UNITED STATES PATENT AND TRADEMARK OFFICE

APPLICATION NO.	FILING DATE	FIRST NAMED INVENTOR	ATTORNEY DOCKET NO.	CONFIRMATION NO.
10/779,471	02/13/2004	Bradford G. Baruh	033151-026	5526

Office Action Summary	Application No.	Applicant(s)	
	10/779,471	BARUH, BRADFORD G.	
	Examiner	Art Unit	
	AARON DUNWOODY	3679

DETAILED ACTION

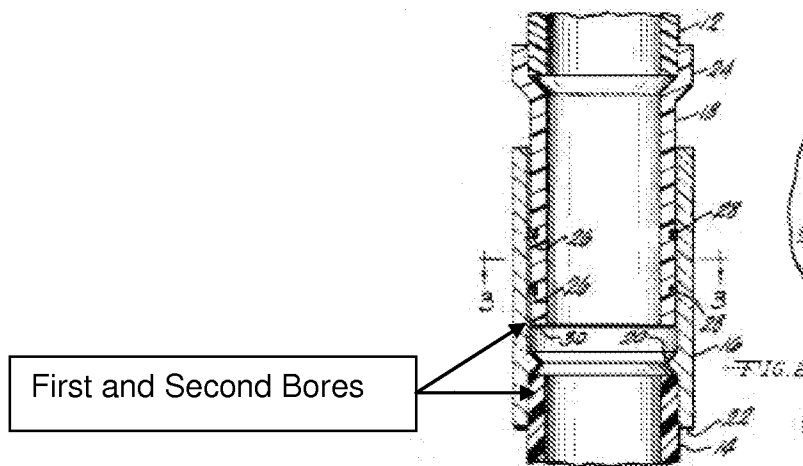
In regards to claim 1, in Figure 2 below, Williams discloses a pipe coupling (16) comprising: an elongated housing having a first end and a second end, the housing defining an elongated bore therein; a stop (20) located on an inner diameter of the housing, the stop located between the first end and the second ends of the housing, wherein a distance from the stop to one of the first and second ends is at least two times a distance from the stop to the other of the first and second end of the housing; a first cylindrical bore extending from the first end to the stop; and a second cylindrical bore extending from the second end to the stop, and wherein each of the cylindrical bores are configured to allow a pipe end to advance into the pipe coupling until reaching the stop.

Williams does not disclose an angle between the first cylindrical bore and the second cylindrical bore is about 15 degrees to about 165 degrees. Waterhouse teaches couplings (1, 5, 6, 9, 13, 14) with an angle between a first cylindrical bore and a second cylindrical bore being about 15 degrees to about 165 degrees, to employ different angles for conventional plumbing (col. 1, lines 45-57). As Waterhouse relates to geometrical structures using plumbing joints, it would have been obvious to one having ordinary skill in the art at the time the invention was made to fabricate couplings with an angle between a first cylindrical bore and a second cylindrical bore being about 15 degrees to about 165 degrees, to employ different angles for conventional plumbing, as taught by Waterhouse.

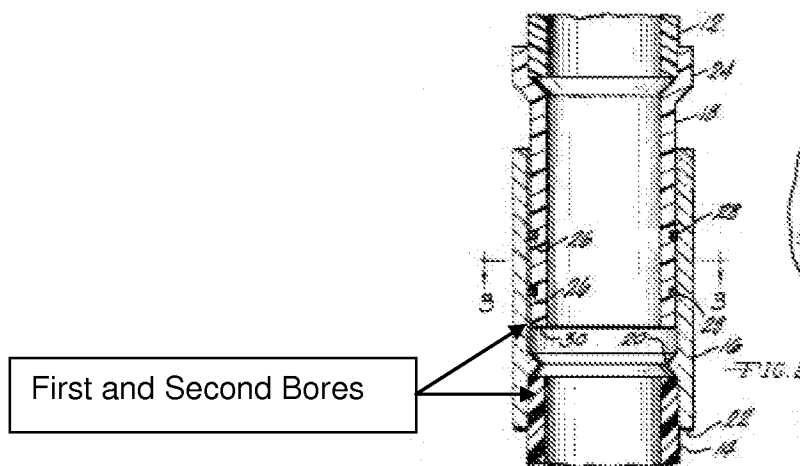
In regards to claim 31, Waterhouse further discloses the angle between the first cylindrical bore and the second cylindrical bore is about 45 degrees to about 135 degrees.

In regards to claim 32, Waterhouse further discloses the angle between the first cylindrical bore and the second cylindrical bore is about 60 degrees to about 90 degrees.
